# ONE SYDNEY HARBOUR

BARANGAROO

R4B SUPPLEMENTARY DESIGN STATEMENT FOR S4.55 MODIFICATION APPLICATION  
June 2021

Ground Floor Wind Mitigation Layout Approved Via Secretary Approval

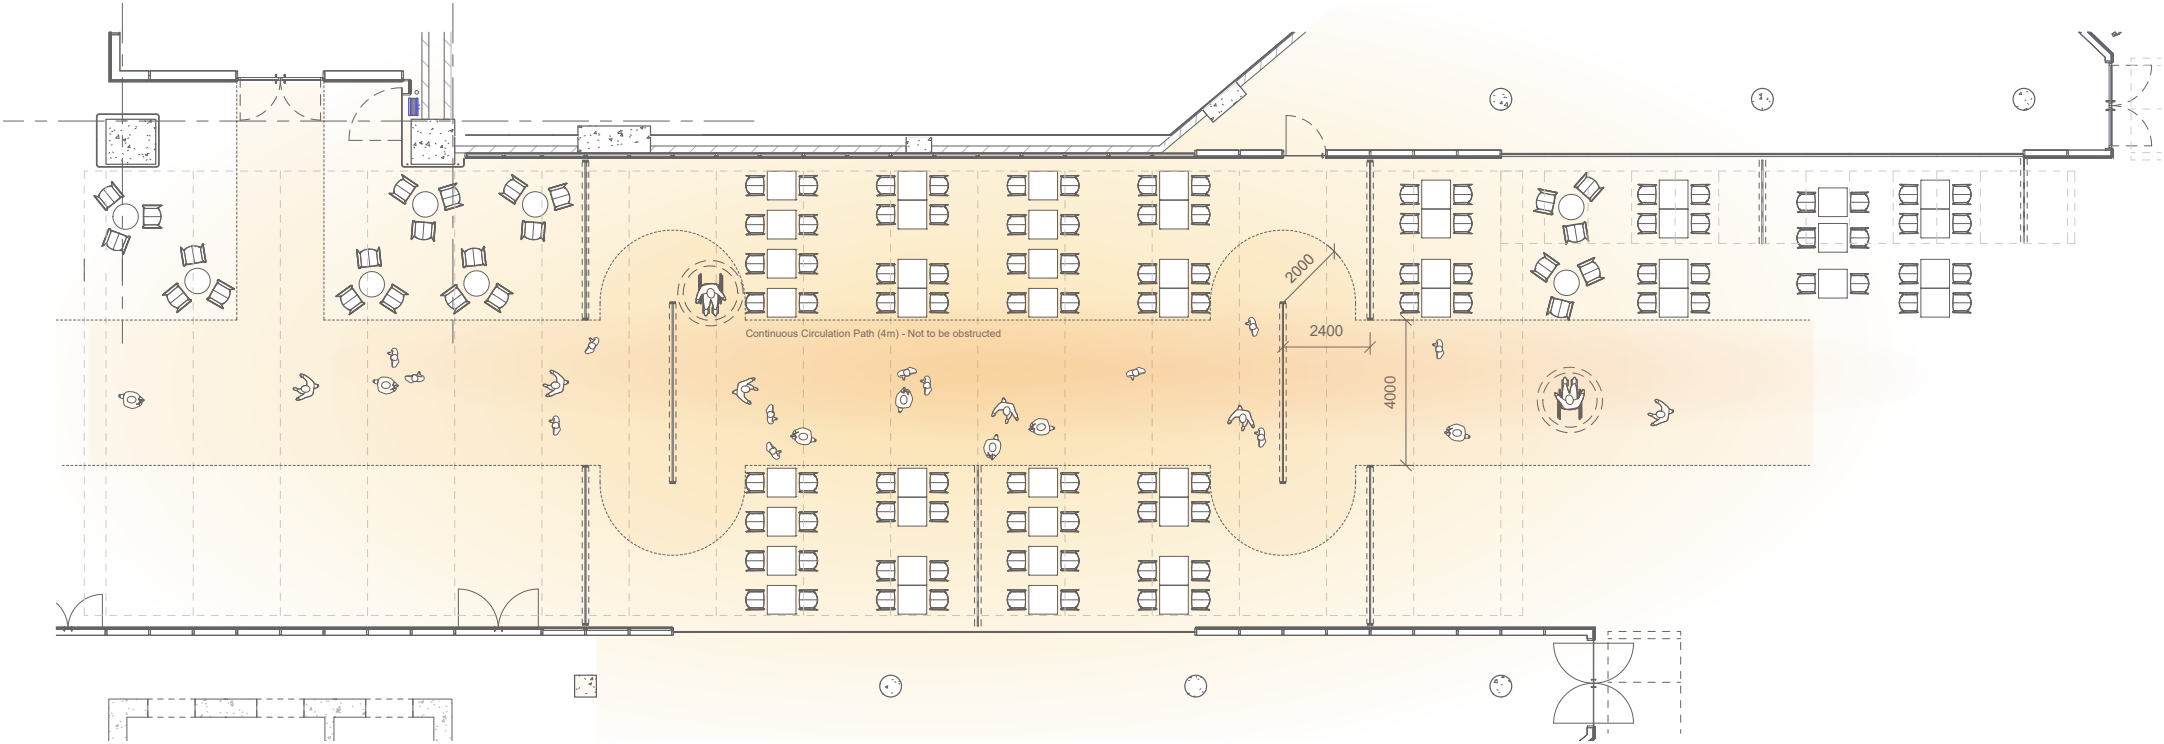
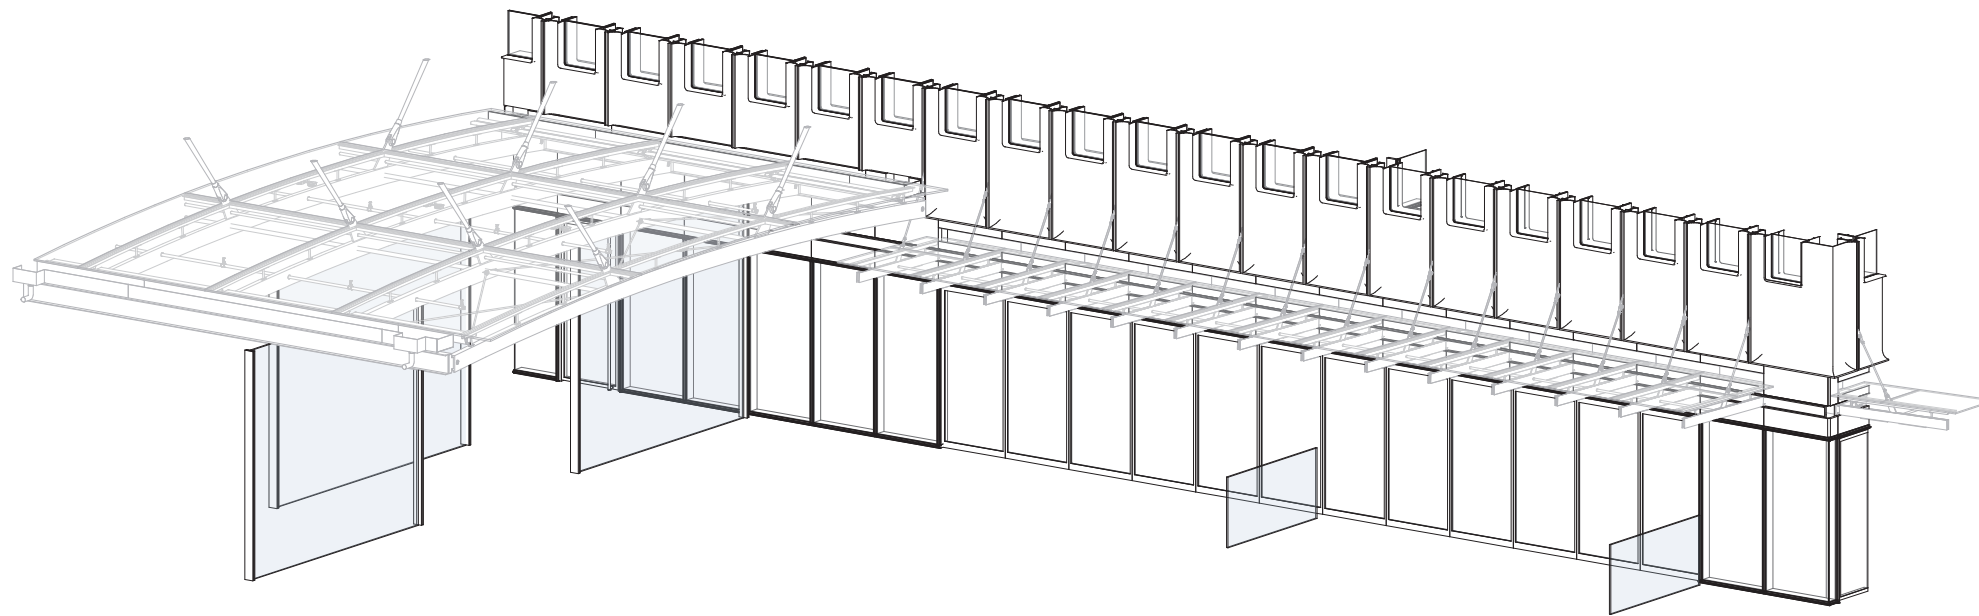
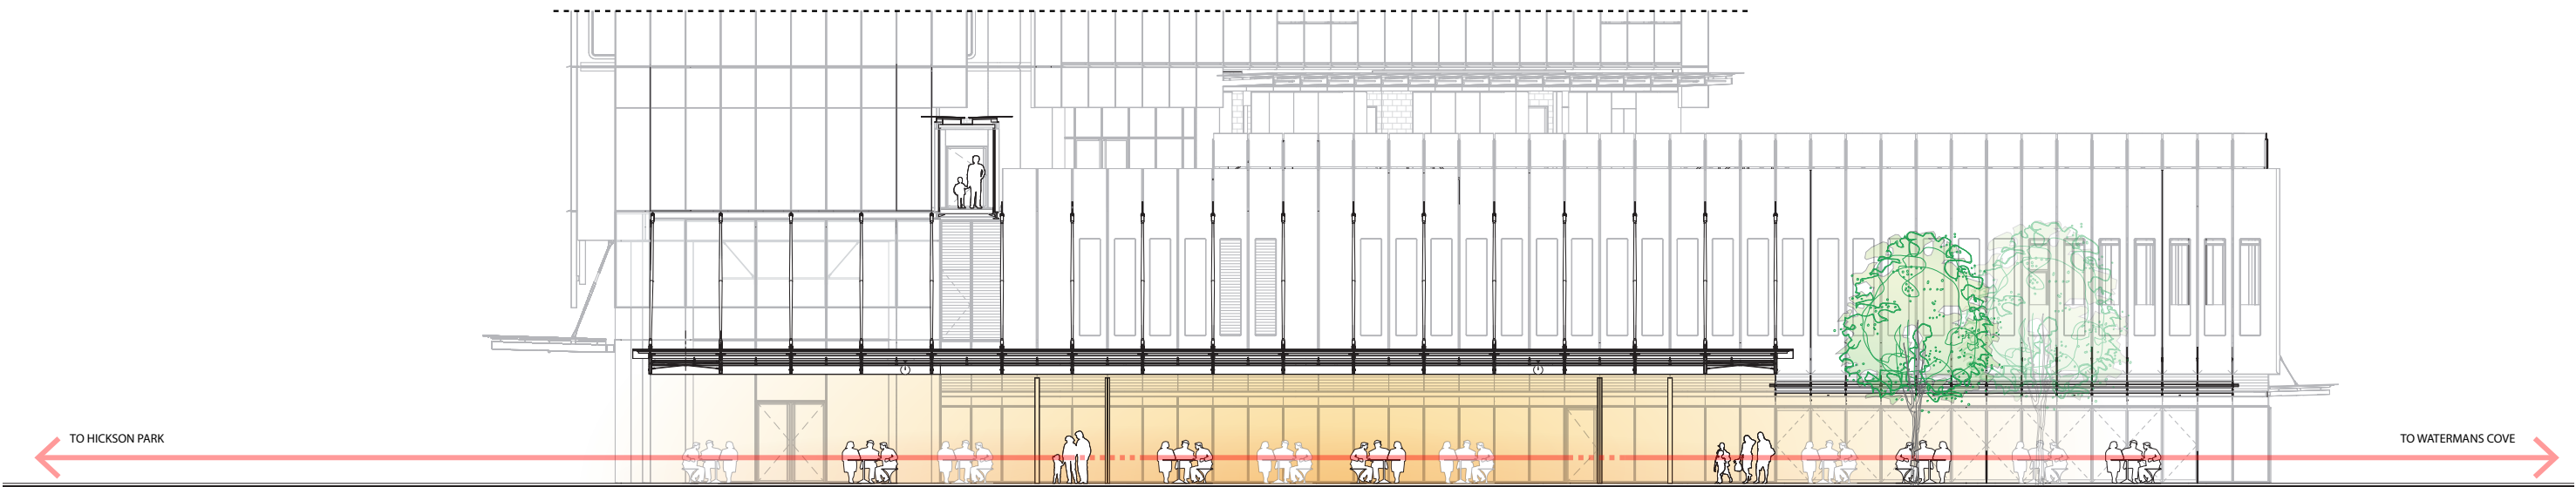
The modification application seeks to transfer the delivery of the strada ground plane and areas from the R4A development consent (SSD 6964) to the R4B development consent. The R4B development consent includes the roof of the strada, accordingly it is considered appropriate to also include the associated ground plane under one planning approval. Under the development consent for R4A (SSD 6964) the wind mitigation measures for the strada space under Condition B5 were approved via a Secretary Approval. This includes the addition of glass wind baffles within the strada. For completeness, these wind mitigation measures are therefore part of the modification, to provide their delivery through Building R4B

Proposed Entrance - Plan

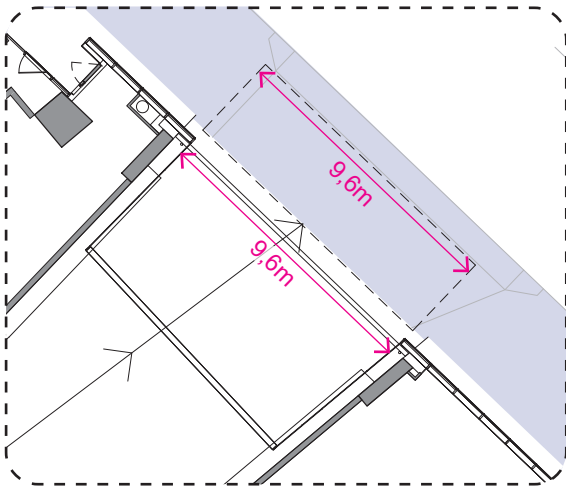
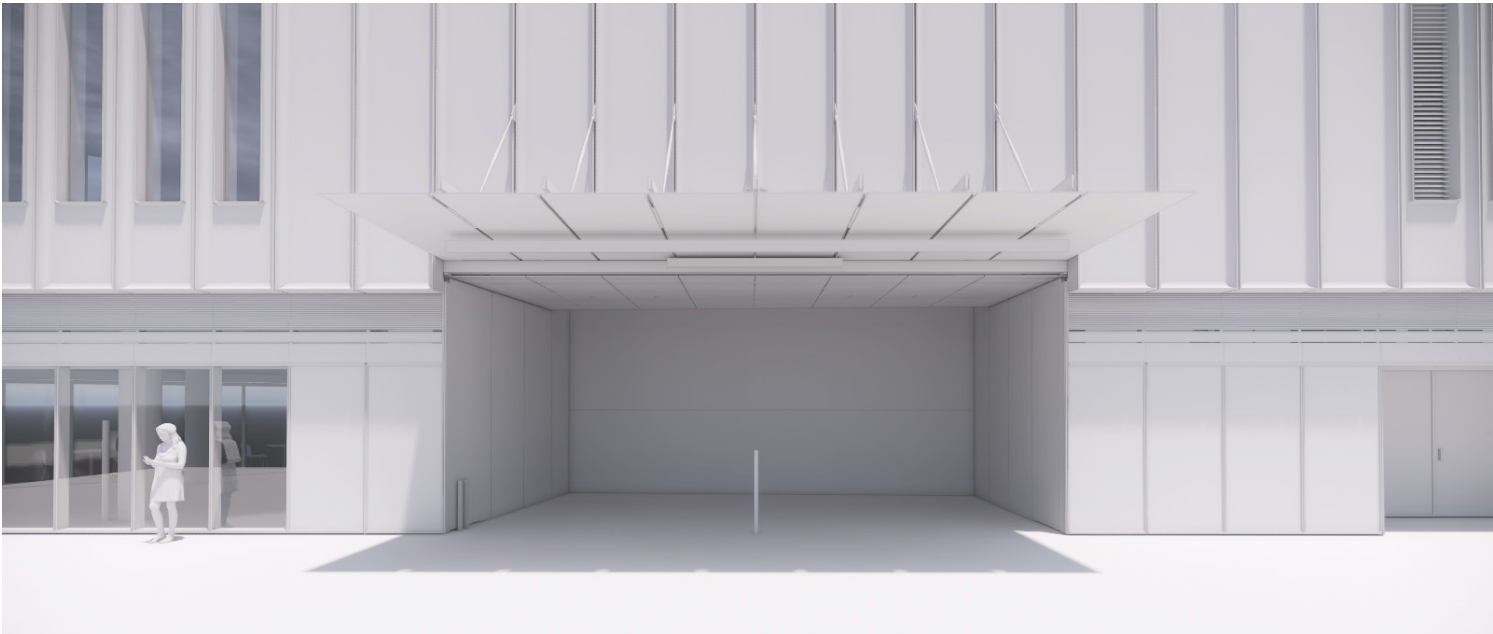
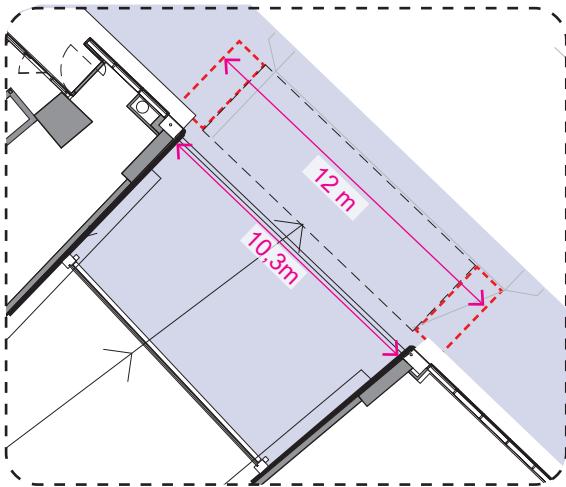
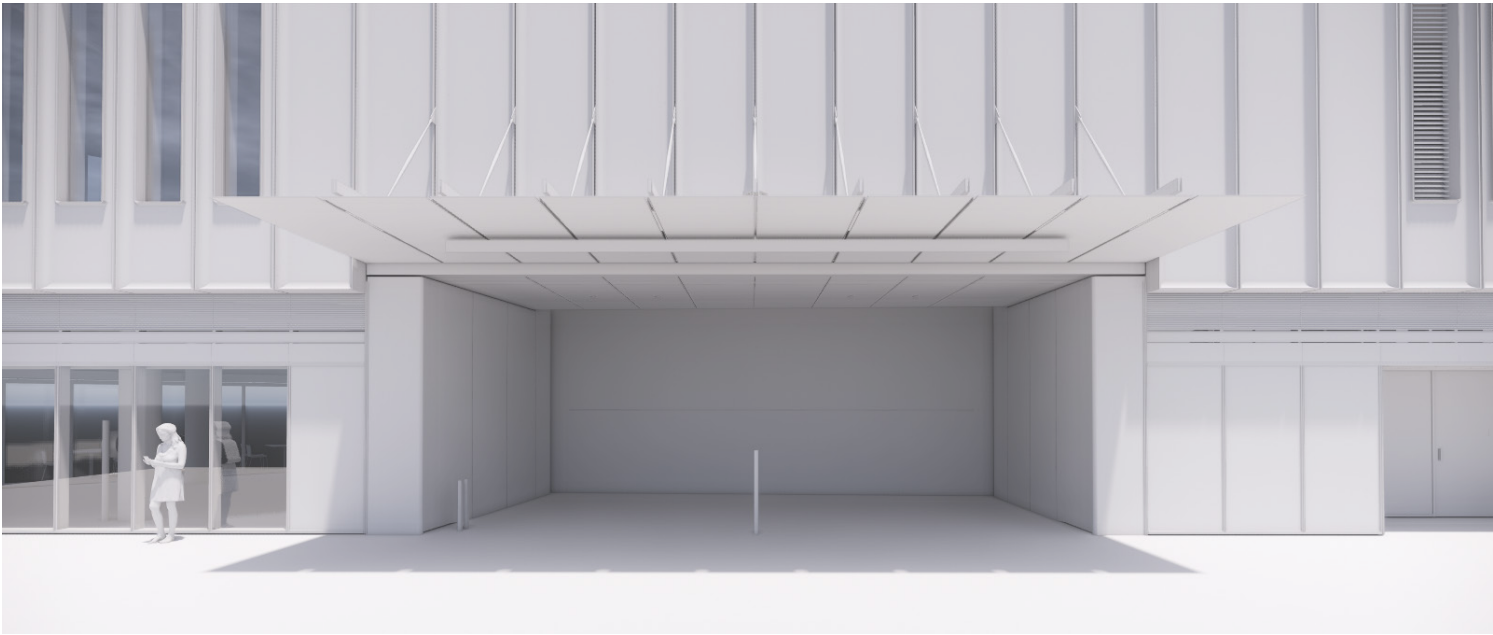
It has been identified that there is a potential risk of impacts to the cladding on either side of the carpark entrance ramp and potentially to other vehicles approaching in the opposite direction. To mitigate this risk, the opening was widened slightly within the bounds of the approved structure. This had the effect of increasing the width of the carpark. As such, the awning was also increased in width to ensure a coordinated design outcome.

A further amendment in this area relates to the extent of paving. In the approved design, the City of Sydney Council stone would be restricted to the pedestrian footpath. On the proposed scheme, the stone is extended until the garage door, allowing a more uniform and refined design.

-  Added awning modules
-  City of Sydney stone extension

Proposed South Facade Skirt and Portal

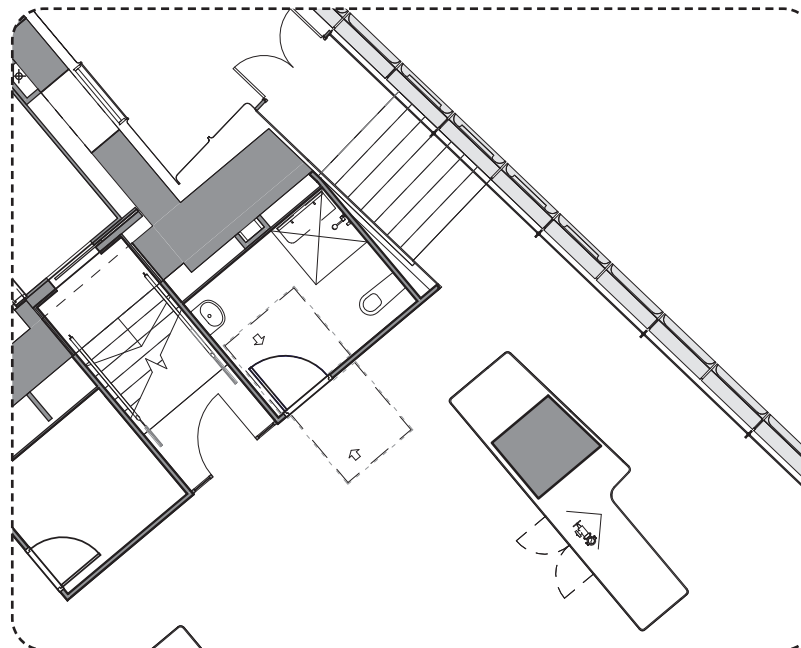
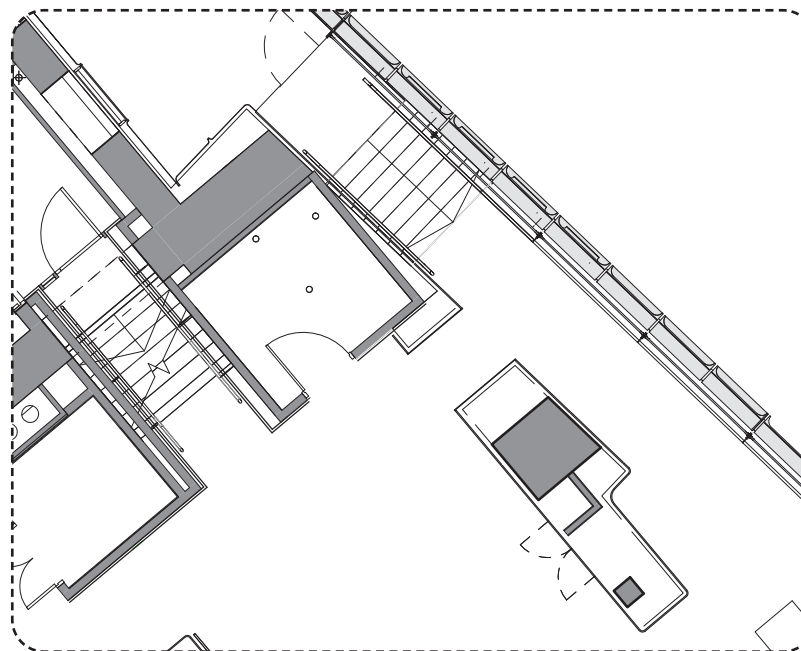
Through the design development of the 'skirt' of the south tower facade which faces Watermans Quay it was identified that there was an open spandrel 'shadow box' that would present ongoing challenges to access and maintain. Through this planning amendment it is proposed to simplify the portal below the skirt in order to close this shadow box and thus create a more robust design.
